Re Beacon Residential LLC Subdivision 40 North Street Tax Map # 6054-29-086785

I have addressed the Comments in the memo from Lanc and Tully dated September 7, 2017 as follows:

Silver Maple onsite showing a large scar and the wood is rotten.

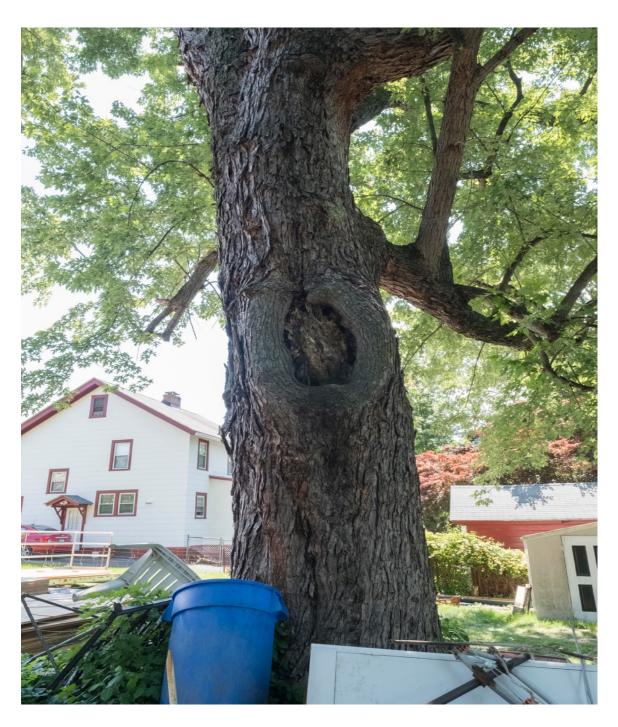
- 3. The 42" tree onsite has been further identified as a silver maple. Silver Maples are fast growing trees that are identified as a poor choice to plant in close proximity to dwellings and other infrastructure due to its aggressive, shallow root system. They are known to buckle sidewalks and driveways, cause foundation damage and clog pipes as well as being prone to rot and decay and weather damage. The existing tree had a large limb removed in the past and the wound has begun to show signs of decay. I have included a picture of the trees damage and the USDA data sheet on Silver Maples showing their characteristics and limitations.
